CITY OF WARRENTON

November 6, 2018

Re: SDR 18-4 and V18-3; Trondheim Acres, LLC ("Tractor Supply")

SITE PLAN
SCALE: 1" = 40'

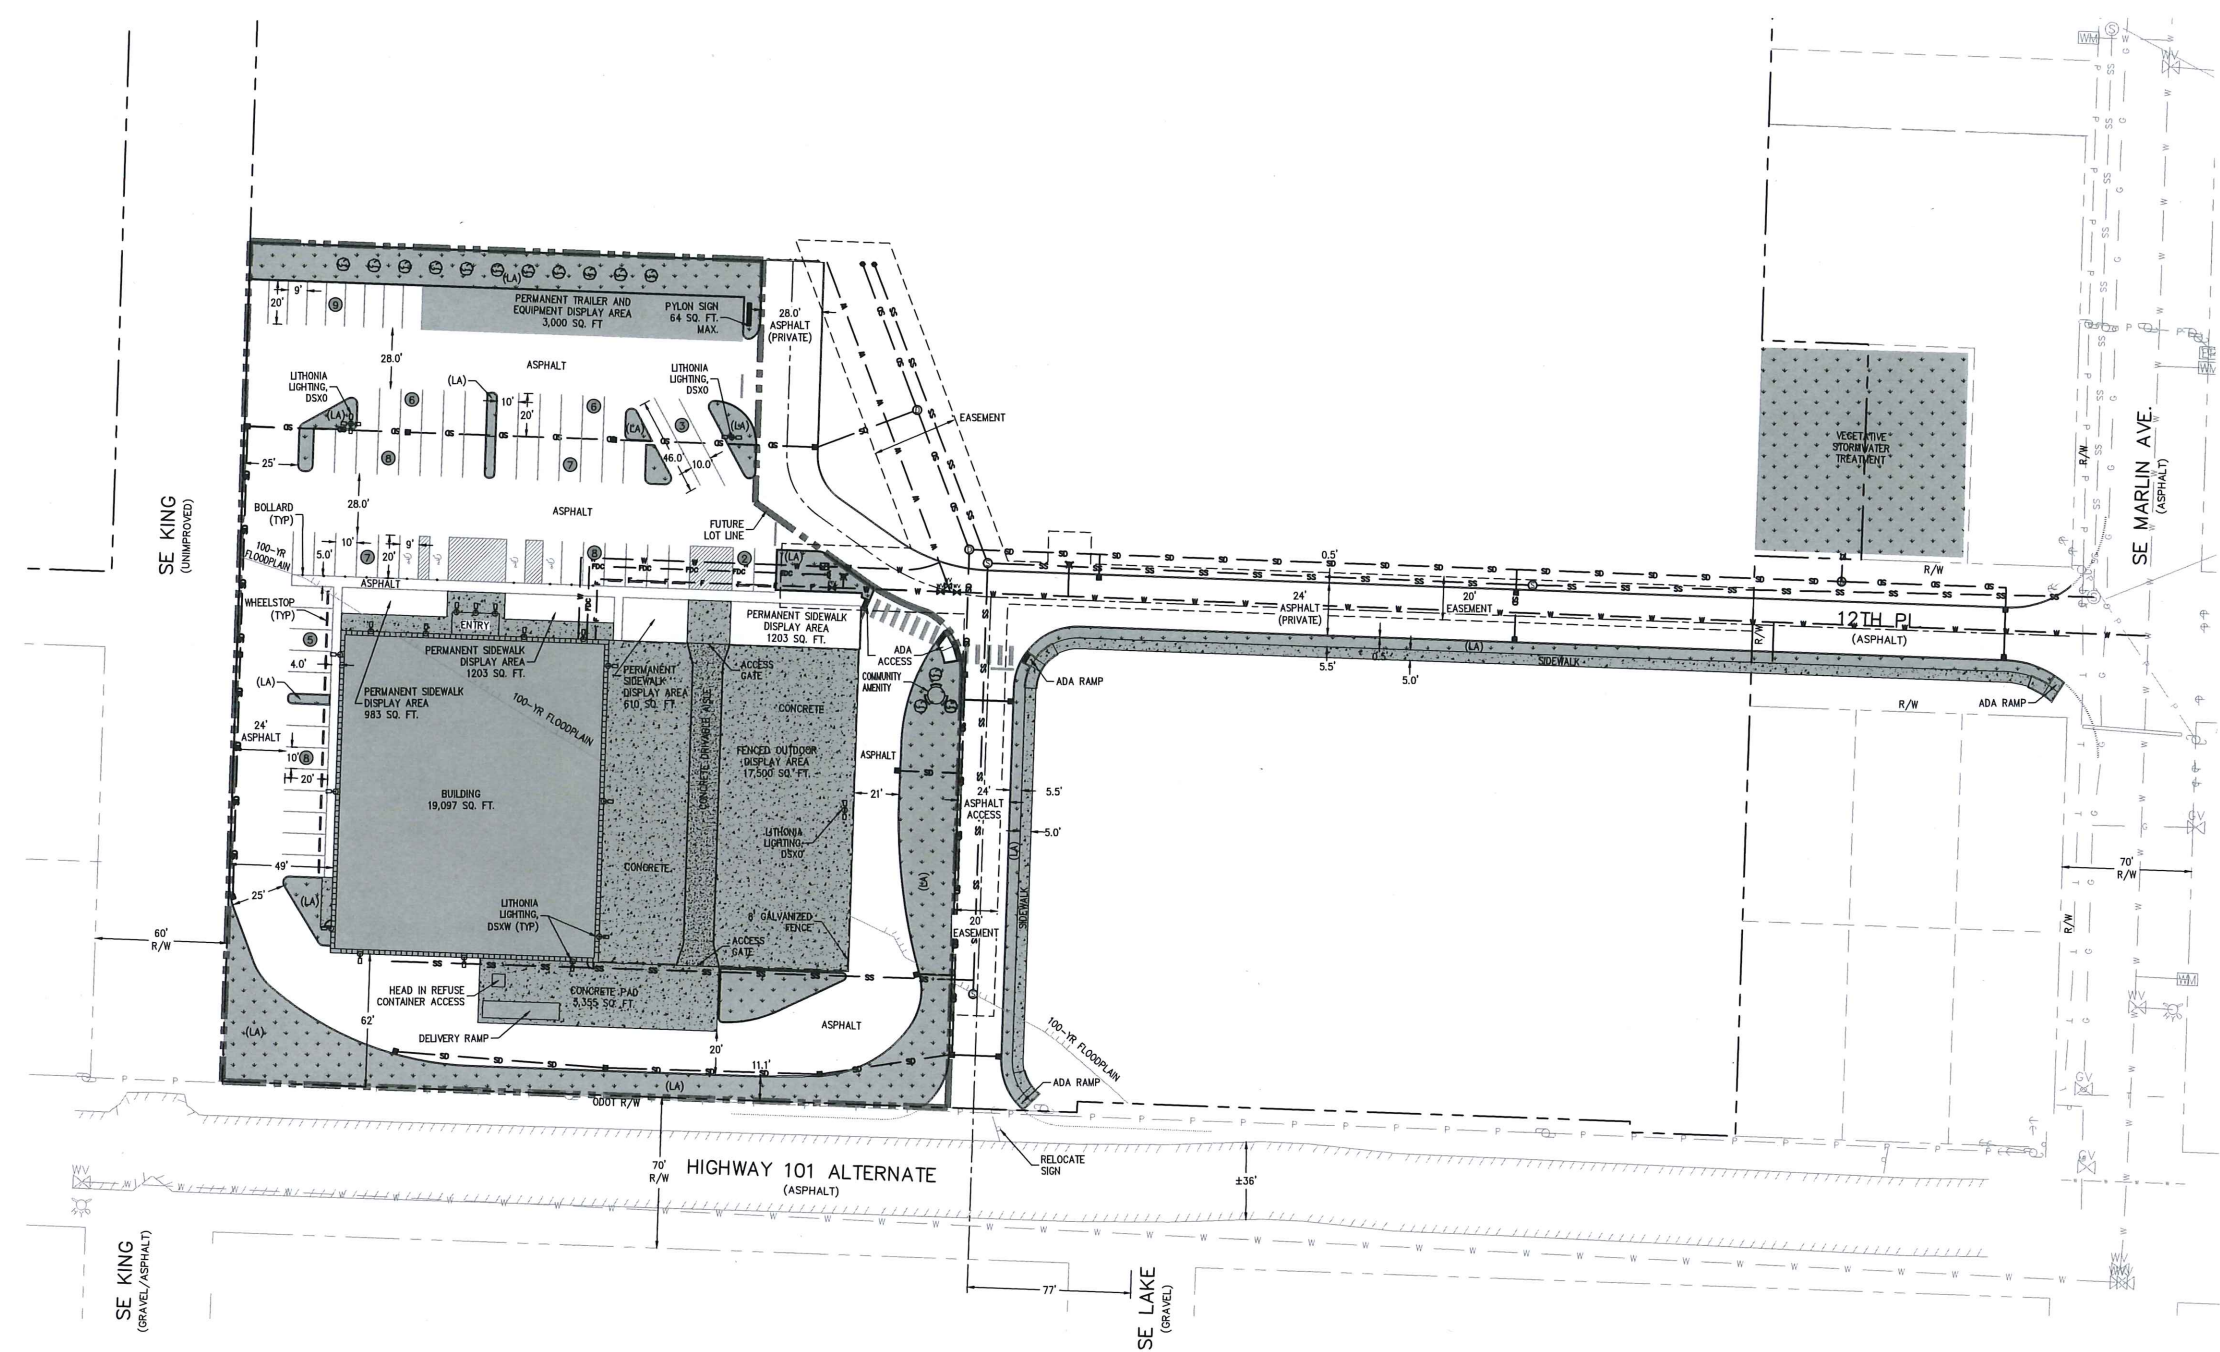
The proposed site plan shows that all parking, sidewalks, driveways, and driveway aprons are to be paved. The plan shows a stormwater detention/treatment pond near the site's SE Marlin entrance. The City's contract engineer needs to conduct a review and provide comments on the stormwater collection system. See conditions of approval.

The proposed site plan shows a new sidewalk along the south side of the private street from SE Marlin connecting to the other access/private street. A sidewalk system will also be located in front of the building. However, outdoor storage sales will cover a large portion of the sidewalk system. In addition, there is no pathway or sidewalk system identified from the off street parking area to the main entrance nor is there a system for pedestrian access along the private street system. The proposal does not meet the requirements of 16.120.030.A.1.

This requirement applies to the mid-block section where the two private street connect. A sidewalk is proposed on one side of the private street, which does not meet the intent of the standard and does not meet local alternative street standards. For these reasons, the Planning Commission can find the proposal is not consistent with 16.120.030.A.4.

There are two proposed crosswalk markings as required by this section as shown on the site plan at the intersection of two private streets and to cross a driveway between the storage yard and landscaped buffer. The materials are not specified. In addition, there are no crosswalks proposed at each public street intersection. The proposal does not meet the requirements of 16.120.030.B.3.

The proposed site plan shows that sidewalks are to be concrete and 5 feet wide. This does not meet the requirements of 16.120.030.B.4. However, the alternative local road standard does allow 5 foot sidewalks on both sides. See conditions of approval.

Based on this calculation, a total of 38 off-street parking spaces are required. The site plan calls for a total of 62 standard spaces plus 3 oversize, 2 ADA standard and 2 ADA van accessible spaces, which far exceeds the standard. The parking code does not have a maximum cap on the number of spaces. The proposed parking plan meets this requirement. Standard is met.

The proposed parking plan with service drive aisles and location does meet the requirements of 16.128.030.A.1 through 6. The proposed parking area in front of the main entrance creates a traffic safety hazard with backing movements into the drive aisle. In addition, a proposed private street does not serve the building directly which would replace the proposed parking area in front of the building and connect to SE King St. See additional findings under private

The clear vision areas associated with the two private streets intersection are not indicated on the site plan. The proposal could meet the clear vision standards as long as landscaping is maintained to these standards. With proper landscape maintenance, the proposal meets the requirements of 16.132.010. See condition of approval.

The site plan shows two storm drainage details. The proposed stormwater detention and treatment system includes a vegetated facility at the northeast corner of the site that drains into a swale system along SE Marlin Ave. A stormwater report by a civil engineer will be required as part of the engineering review phase.

LANDSCAPING

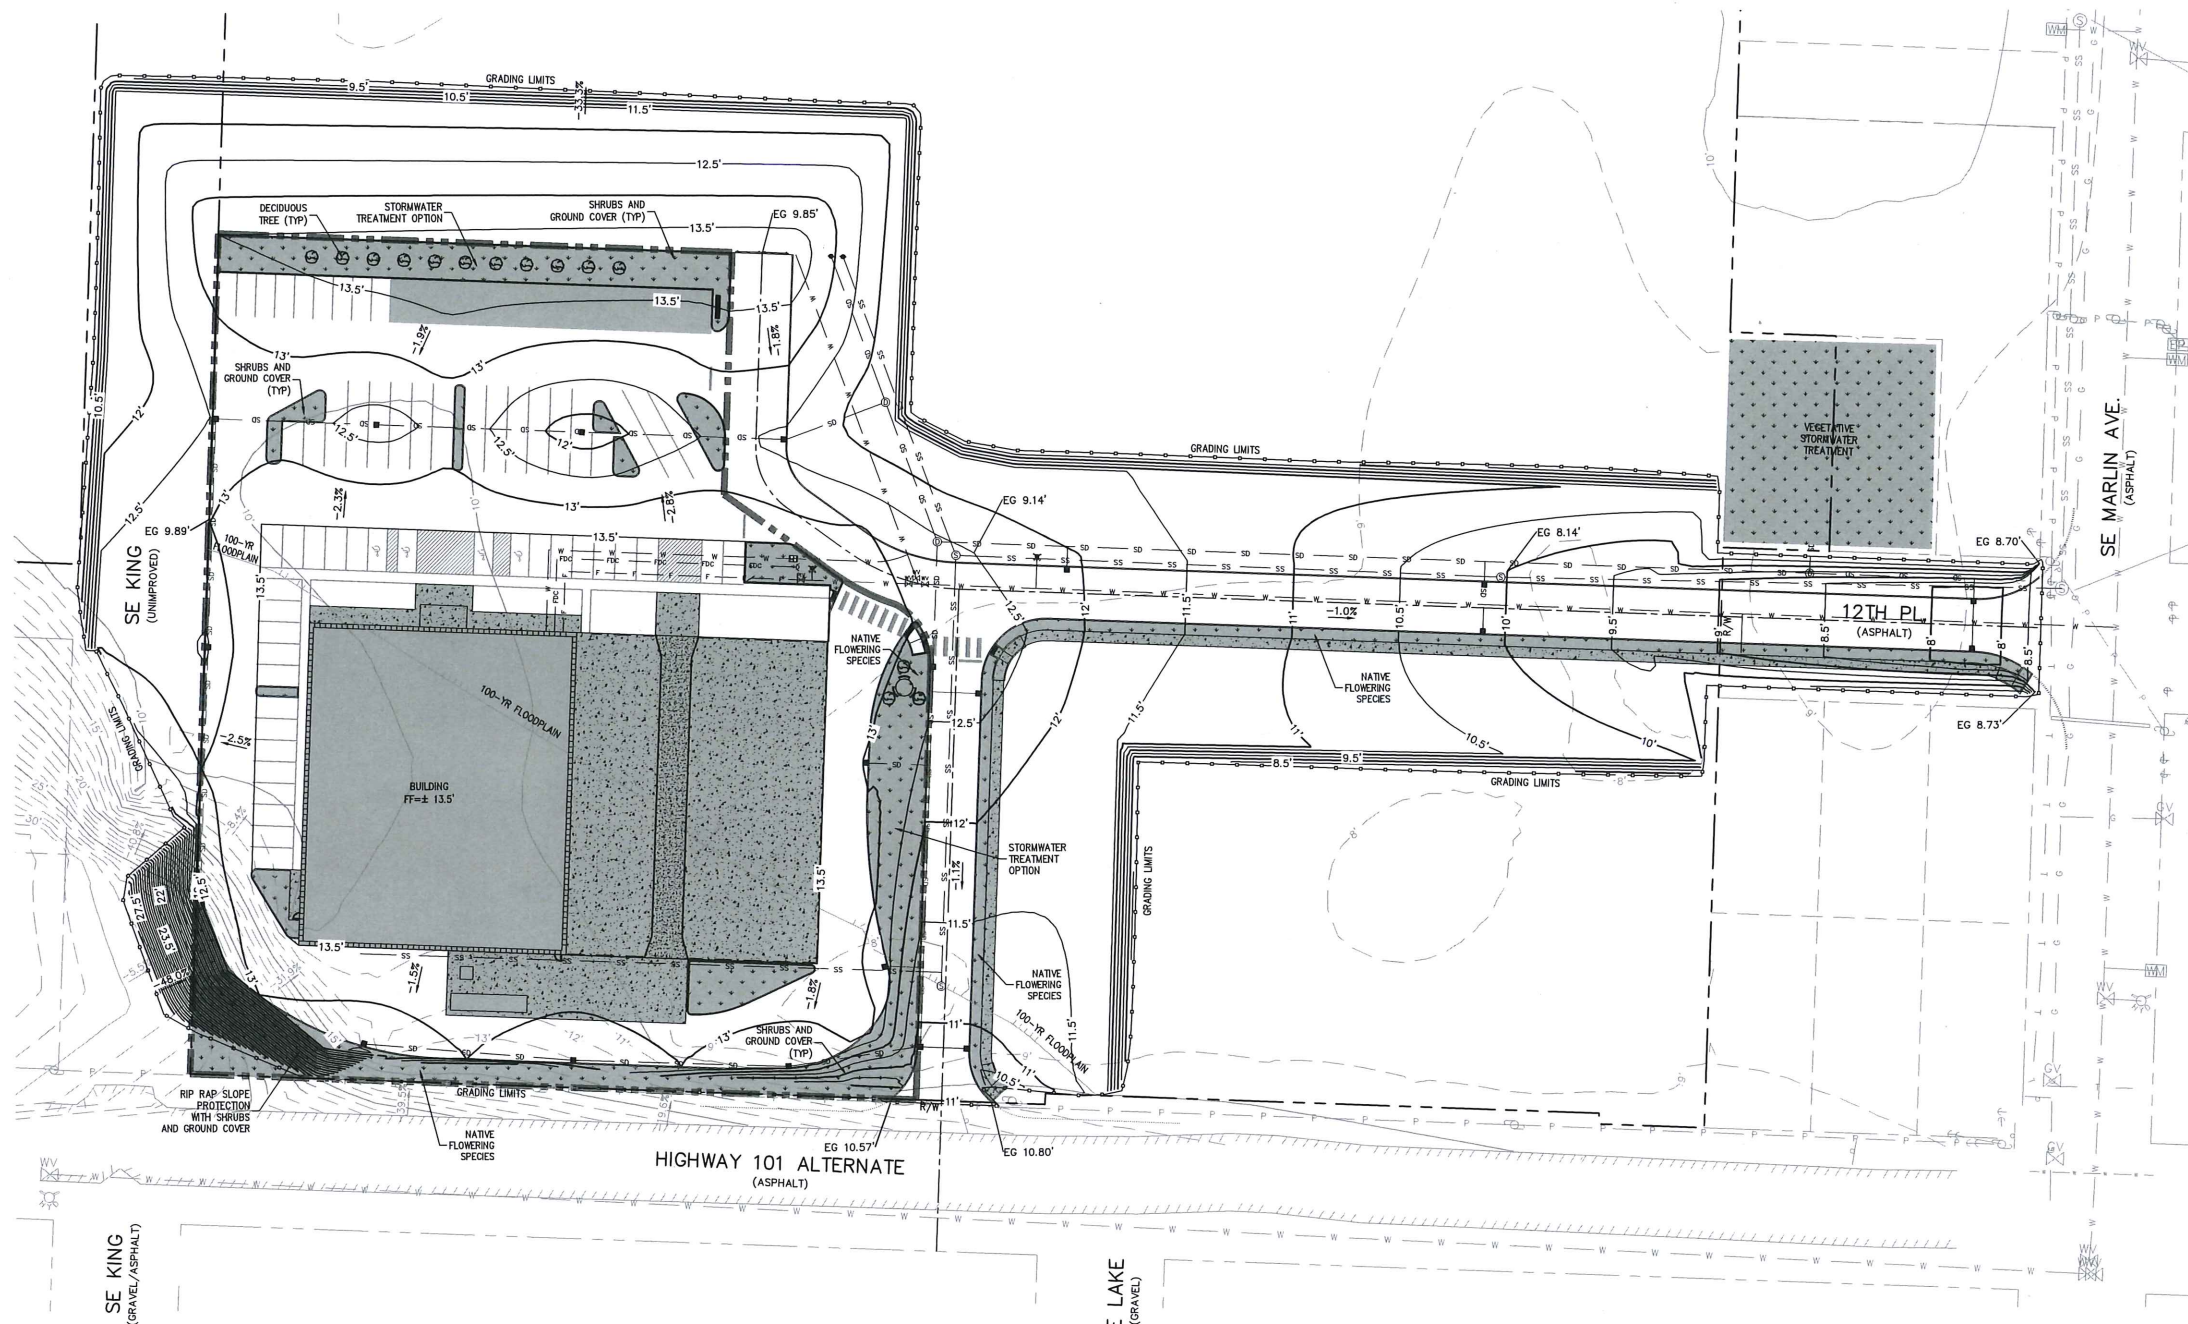
The landscape plan submitted with the application materials indicates that about 15 percent (17,778 SF) of the site is to be landscaped, which is the absolute minimum to comply with the standard. This complies with the requirements of 16.124.070.C.2.

The proposed landscape plan identifies a mix of native trees, shrubs, and ground cover to meet the minimum requirements of 16.124.070.D. There are no details on the groundcover material or percentage of coverage, hardscape features, or tree caliper size. There is no significant vegetation to be preserved with the exception of two Douglas Fir trees at the SE Marlin entrance. Based on a site visit, there is non-native vegetation that must be removed. The requirements of this section have not been met. See conditions of approval.

The proposed landscape plan relies on a minimum amount around the perimeter of the site and in the parking area. It is not used to define pedestrian areas or create a focal point of interest of visual cue. The site plan does show a row of deciduous trees that frame the north property line and additional landscaping along the east side adjacent to the private street. Native flowering species are proposed to conform with “year-long color and interest” standard. The outdoor storage areas were addressed under C-1 design standards section. The graded and steeply sloped area on the southwest corner does indicate rip rap and shrubs and ground cover but no details. In addition, there are no details for the proposed stormwater detention treatment area. See conditions of approval.

Proposed parking lot landscaping is indicated, but there are no percentages provided that demonstrate compliance with subsection E.2. The landscape plan calls for eleven (11) trees along the north property line adjacent to a proposed permanent trailer and equipment display area. No other trees are indicated on the site plan. Based on the 1:5 ratio of trees to parking spaces, a minimum of 14 trees are required. Customer parking rows of six spaces are broken up by landscaped islands that meet this standard. However, based on the total review, the proposed landscape plan does not meet the requirements of 16.124.070.E.2.

The landscape plan does not show an irrigation system for the landscaped areas. Native plant species are generally drought tolerant after an establishment period. The project shall include irrigation for a two-year period to meet the requirements of 16.124.070.F.
